**FINAL  
ENVIRONMENTAL ASSESSMENT  
\* MAUNALUA BAY DREDGING, OAHU \***

**DEPARTMENT OF LAND AND NATURAL RESOURCES**

**OCEANIT LABORATORIES, INC.**

**October 1998**

FIGURE III-8. MARINE BIOLOGICAL SURVEY AREAS

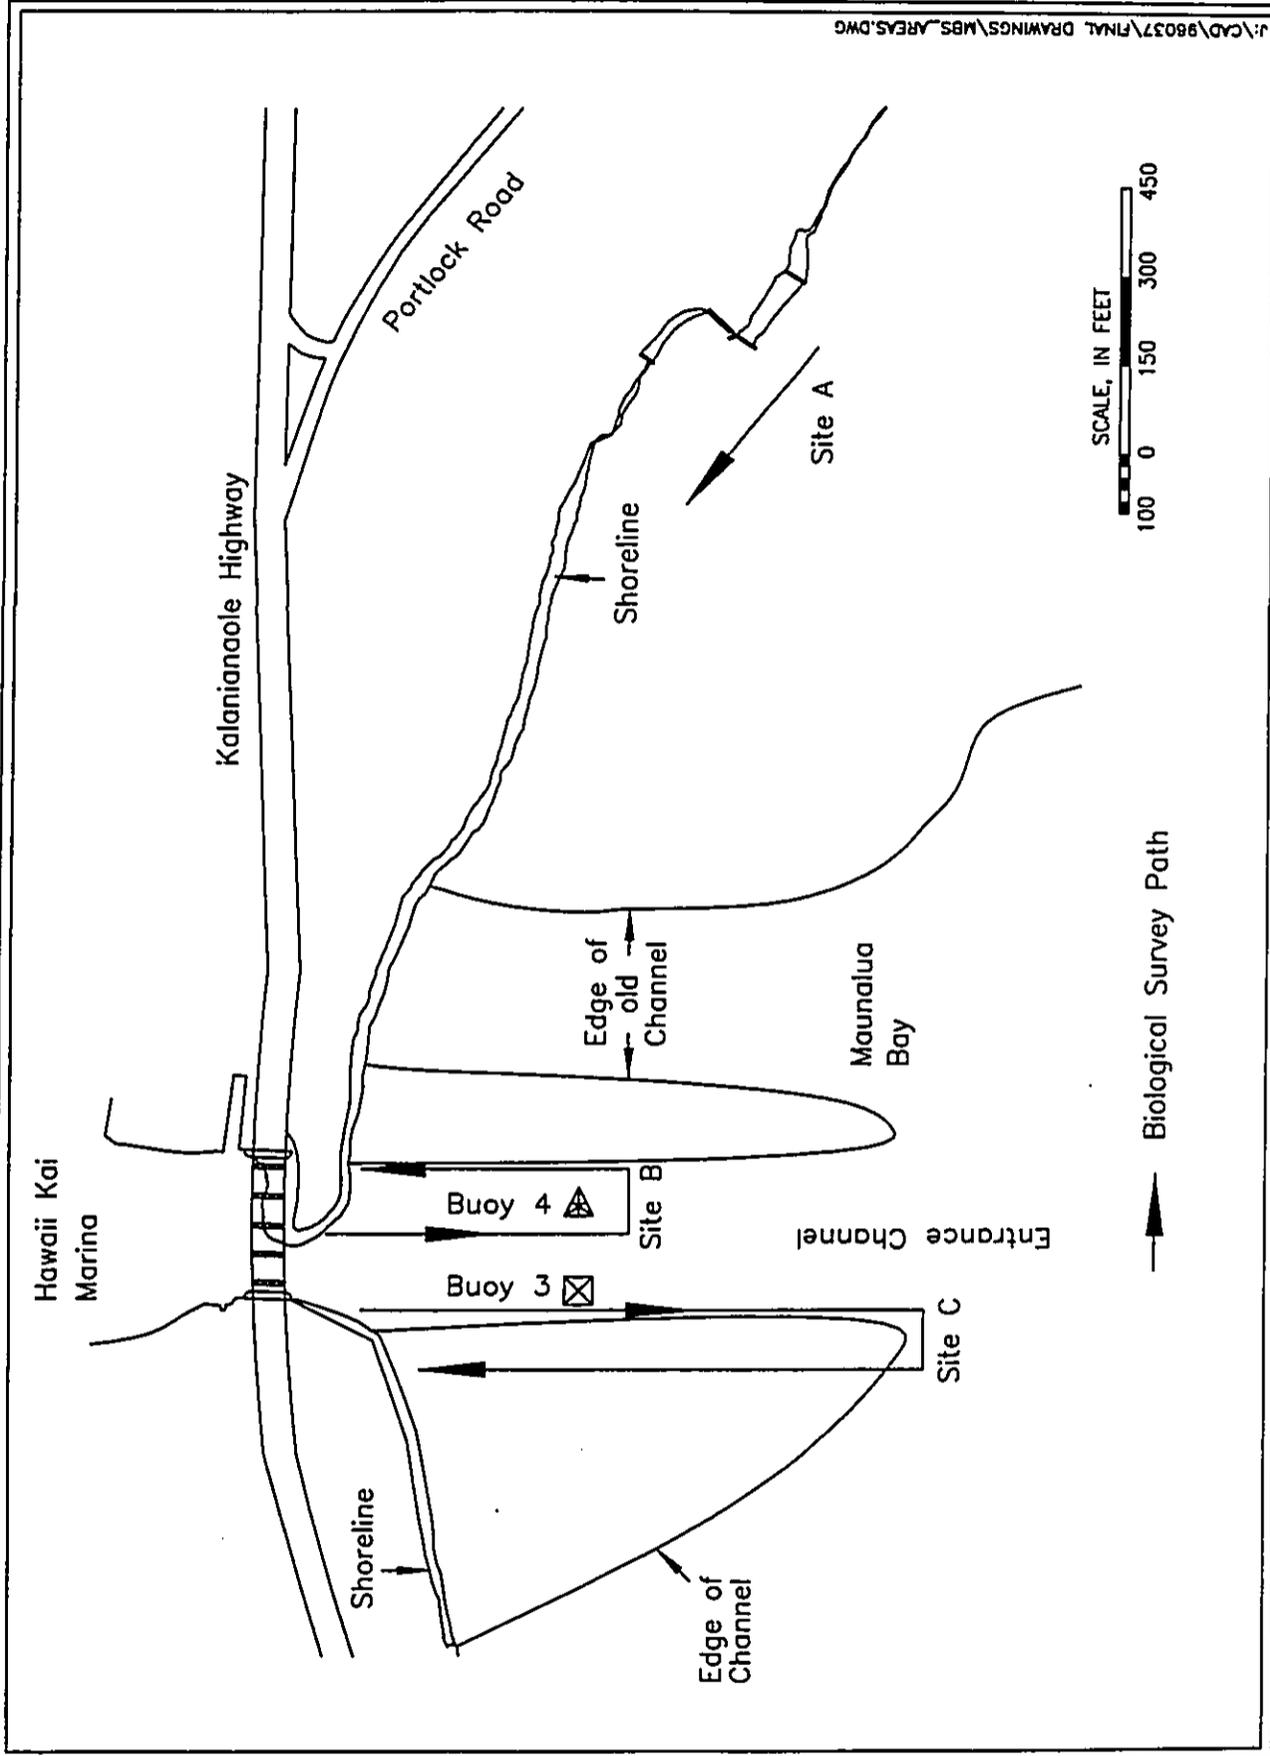
The term *touch point analysis* is used consistently but is not defined in the document. The final EA should include a brief description of this methodology. Many of the biological observations are referenced to various buoys which are ambiguous on the maps. Figure III-8, which shows the biological survey paths, contains some unlabeled lines that should be defined in the final document.

Touch points are at specific intervals along the transect tape measure. At each point substrate and biota types are identified. Buoy locations are shown in Figure III-2. The unlabeled lines in Figure III-8 are either shorelines or reef edge lines visible in aerial photographs. These will be labeled in the final EA.
